Flood Risk Technical Note: Additional information

Regulation 25 Response

Didcot HIF 1

Oxfordshire County Council

Figure 1 Water Level Difference Map between Baseline and Scheme with 10mm Model Tolerance banding applied

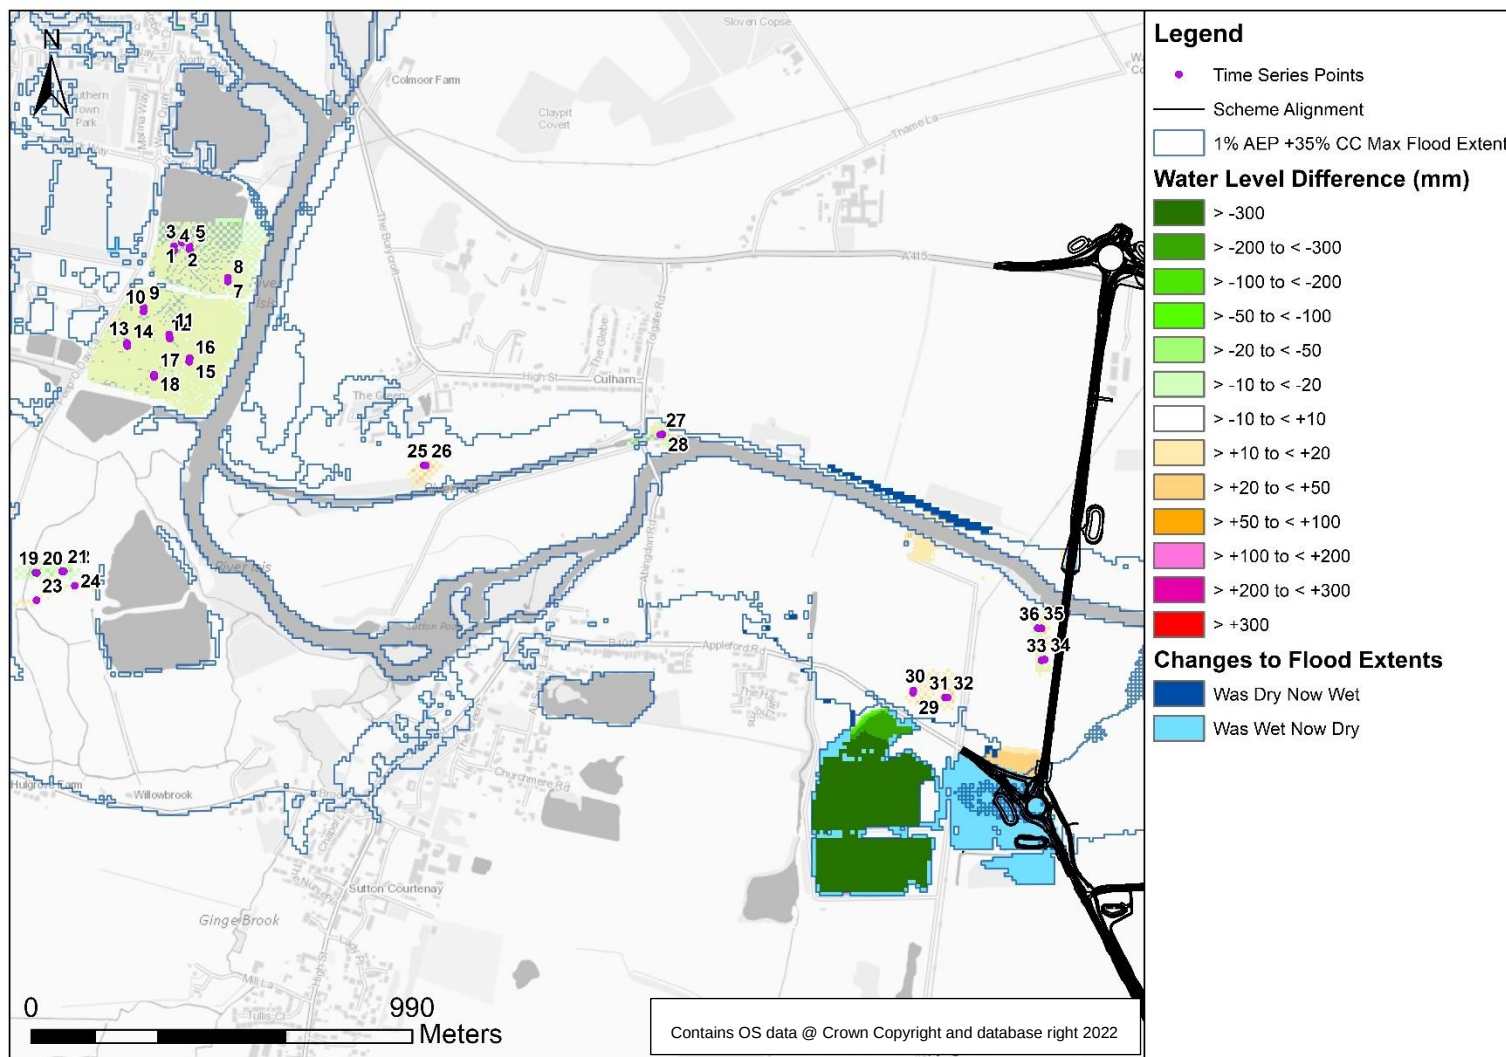
- 1.13 Figure 1 shows the location of 36 TuFLOW Plot Output (PO) points which were added to the model to extract high resolution water level time-series results. The water level difference mapping in this figure (previously included in the FRA) shows differences greater than +/-10mm. As described throughout this section, after undertaking more detailed analysis, it is not considered appropriate to present maps showing differences greater than +/-10mm. Instead, on consideration of model performance and model confidence, the final water level difference mapping has been adjusted to show differences greater than +/-20mm.

- 1.14 36 points were analysed in areas where the water level difference mapping included in the FRA indicated impacts of greater than +/-10mm. As shown in Figure 1 within these areas there was some variability in the magnitude of water level difference between model cells (a 'hatched' effect can be seen in the mapping). It is the variability in the water level difference mapping that has been the focus of further investigation.

- 1.16 As seen in Figure 1, PO points 1-18 are located west of the River Thames, south of Abingdon (between the marina and wastewater treatment works). The time-series results in Appendix A show that at each point, the modelled water levels for the Baseline and Scheme models are within $\pm 10\text{mm}$. This shows that across these areas there is no significant or systematic increase in flood level because of the scheme.

Figure 2 Cross-section of Water Level (HMAX) adjacent to PO points 1 and 2 in the Baseline 1% AEP event plus 35% climate change event

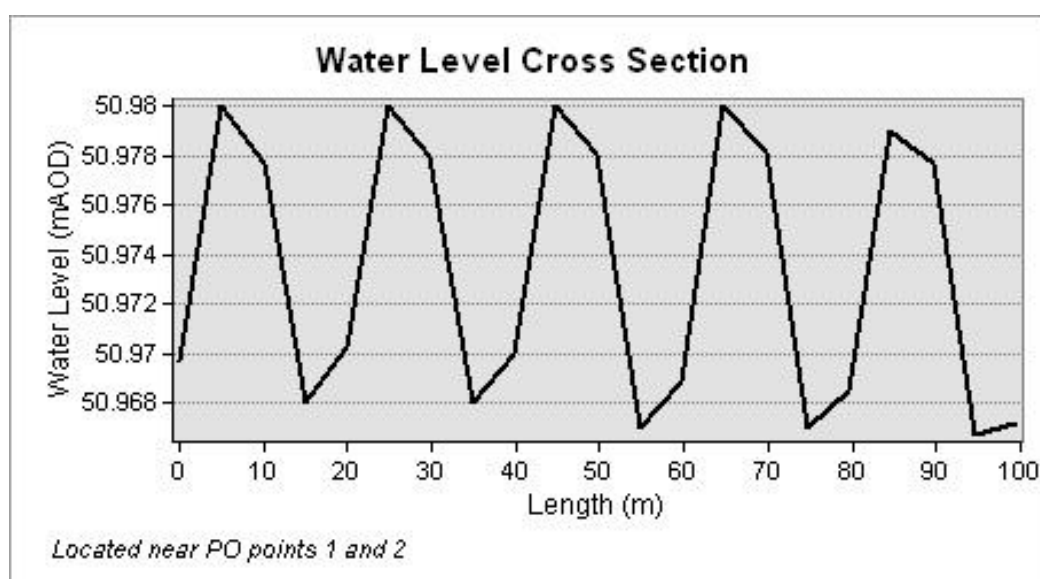
- 1.17 The variability in water level difference that is indicated by the hatching in Figure 1 indicates that there are minor variations in the maximum modelled water level between cells. This is illustrated in the cross-section of water surface profile taken across this area (from PO point 1 to PO point 2) shown in Figure 2. The variation in maximum water level between cells is minimal (approx. 0.01m) across 10m grid cells, with a baseline flood depth of approximately 2m in the 1% AEP plus 35% climate change event.

- 1.18 The minimal variability in water level between the cells is a consequence of minor instabilities in the 2D model in these areas of existing waterbodies. The instabilities were already present within the original 2018 Sandford to Mapledurham model. It is evident in the 2018 model and report that the previous project team had taken steps to reduce this instability but had not removed the instabilities completely. The 2018 model included stability patches at the 1D/2D interface along riverbanks but this did not completely resolve the stability issues. The sudden change in flow resistance/ Manning's roughness values (N) assigned in the model between the existing waterbodies and connecting floodplains further exacerbates these instabilities.

Figure 3 Water Level Difference Map between Baseline and Scheme with 20mm Model Tolerance banding applied

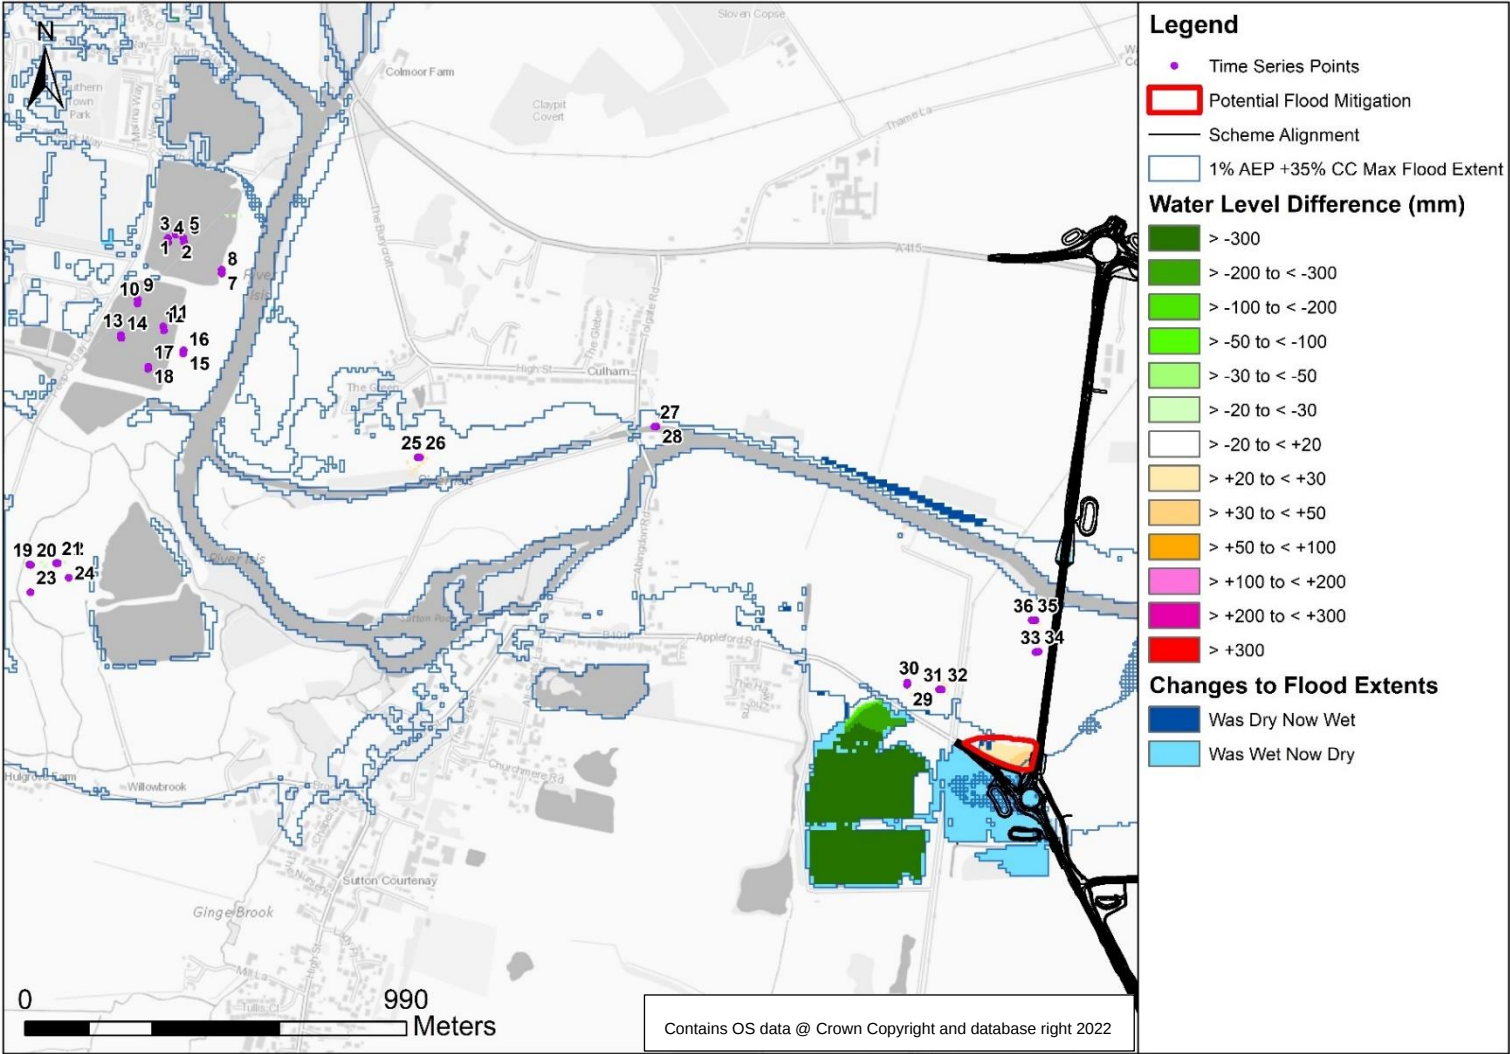
- 1.37 Figure 3 is an update of the water level difference map, showing impacts greater than +/-20mm. The re-formatted figure shows more clearly where there are predicted to be impacts of the scheme.

- 1.38 There is one area where water levels are predicted to increase by more than 20mm. This is directly adjacent to the northern arm of the Sutton Courtenay roundabout. This is highlighted in red in Figure 3.

- 1.39 This area is showing an increase of water level of up to 40mm between the baseline and scheme scenarios. This impact is caused because the proposed scheme cuts off an existing

overland flow path at the roundabout. Where most of the overland flow passes through the viaducts in the proposed scheme, there is a small area of pooling which cannot flow through these viaducts where these depth increases are seen. This area is now incorporated into the scheme and is to be purchased by OCC, who can locally manage this increase in flood risk without any consequence on road users or third parties.

Appendix B Model Mass Balance

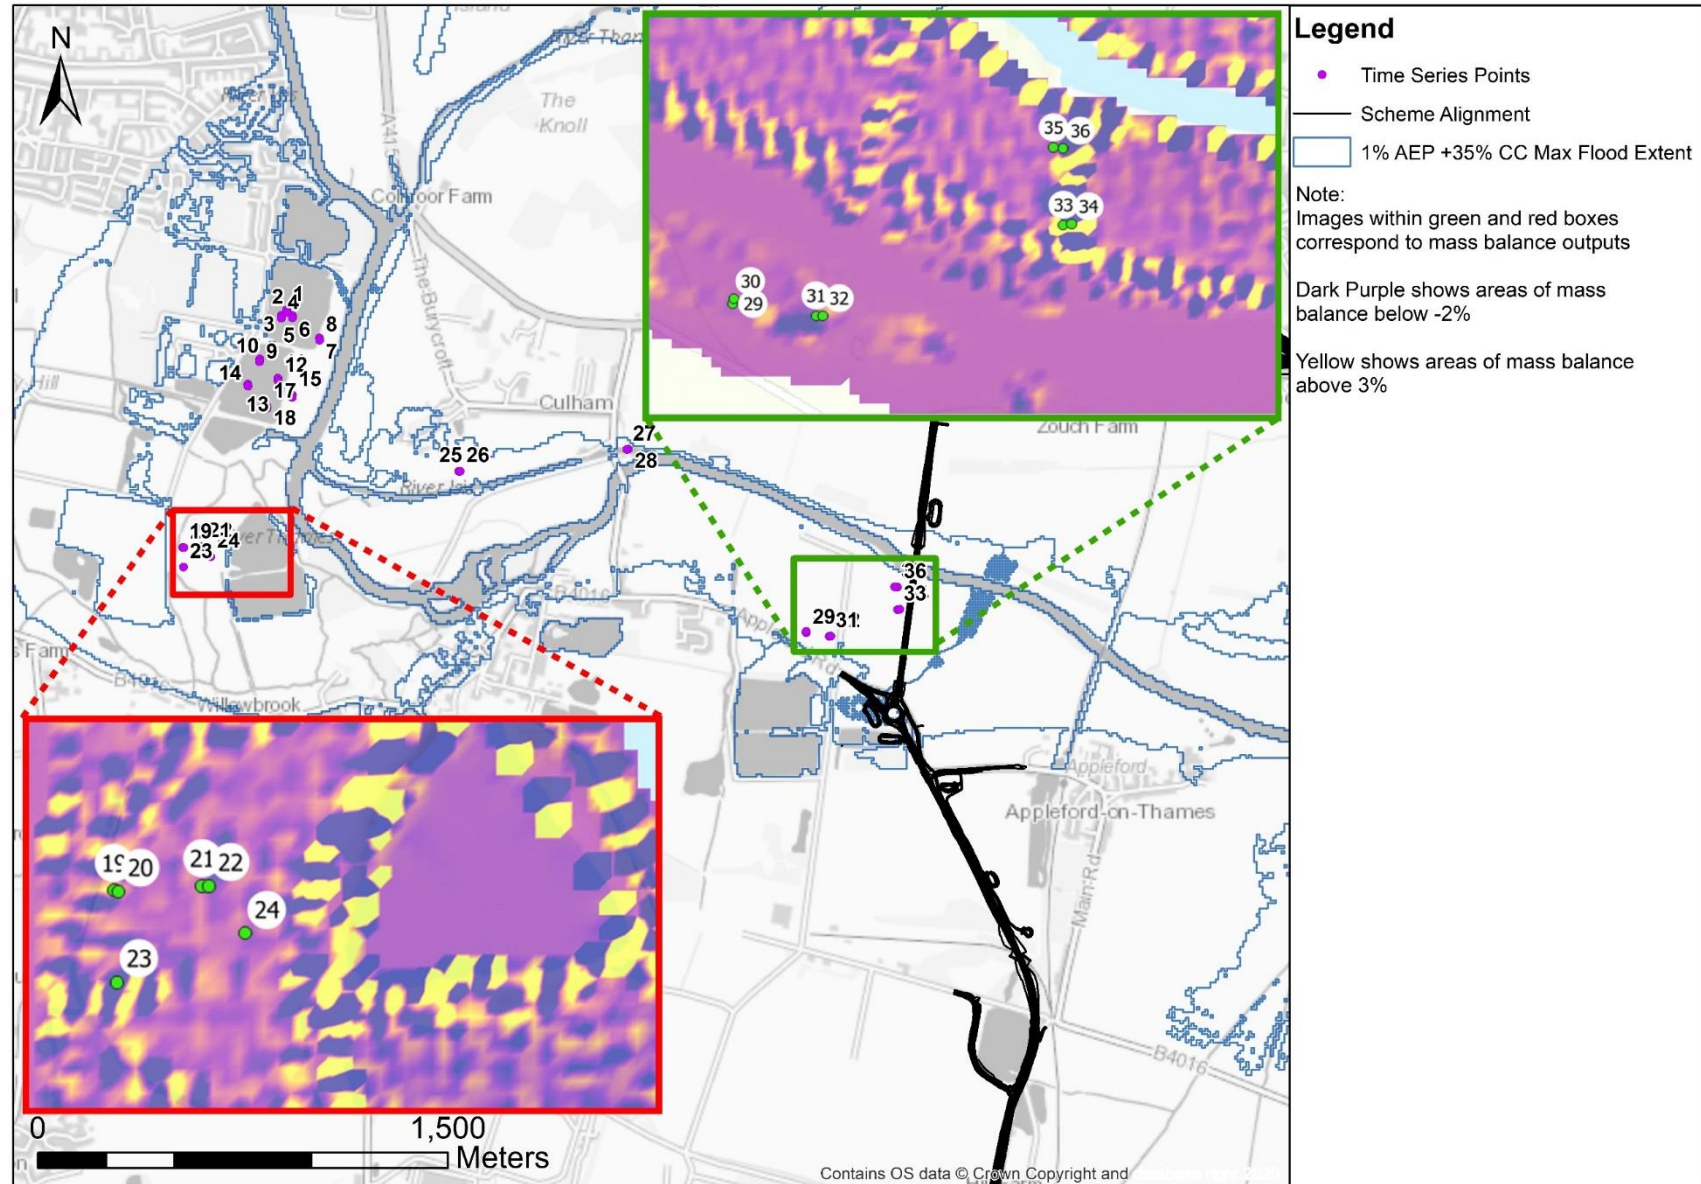
- 1.24 Mass balance output is a measure of 'model health' and shows the balance of water flows in to and out of an area. A mass balance error of greater than +/- 1% can be a sign of model instabilities². The mapped 2D mass balance outputs extracted from the model shown in Appendix B show that the areas of water level variability between cells (the hatched areas in Figure 1) coincide with areas of mass balance greater than 1%.

Below are two screenshots of the model Mass Balance, from the baseline 1% AEP +35% Climate Change event. As discussed, values of +/- 1% are considered to be an indicator of model instability. In the maps, areas shown in dark purple have a mass balance of -2%, and yellow areas have a mass balance of +3%. It can be seen that the PO points placed in the areas of 'hatched' Water level difference results coincide with the areas of high mass balance variation. This means that the variations here are a result of model stabilities, not a result of the proposed scheme.

FLOODPLAIN
COMPENSATION AREA
SHEET 1 OF 1

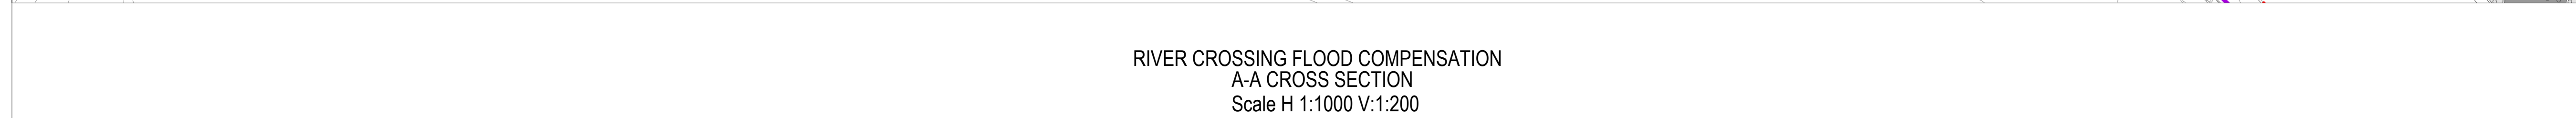
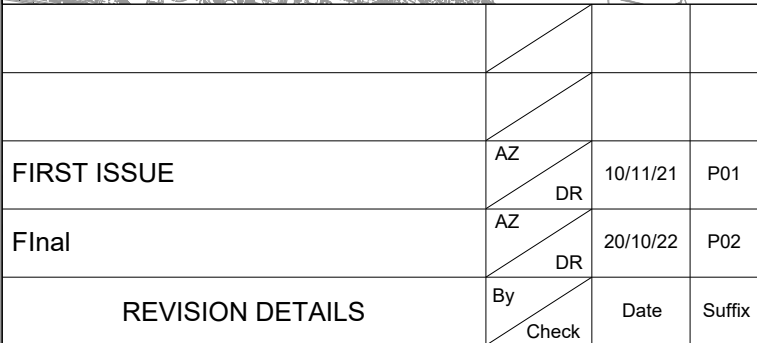
- 1.42 Secondly, in addition to the approach of an open span viaduct crossing design, Level for Level Flood Compensation is presented in Table 4.3 of the FRA and drawing RIV_PD-ACM-GEN-SW_ZZ_ZZ_ZZ-DR-CH-0011 (Appendix C).

- 1.43 The purpose of this compensation is to offset the footprint of the scheme within the floodplain, and within the redline boundary, as seen in Appendix C. This was calculated in 200mm increments in the FRA. This has now been revised to the 100mm increments as requested and is shown in Table 1.

- 1.44 This revised table shows that there is no loss of floodplain volume in any increment of level, and indeed there is a net gain at each ground level increment as a result of the scheme.
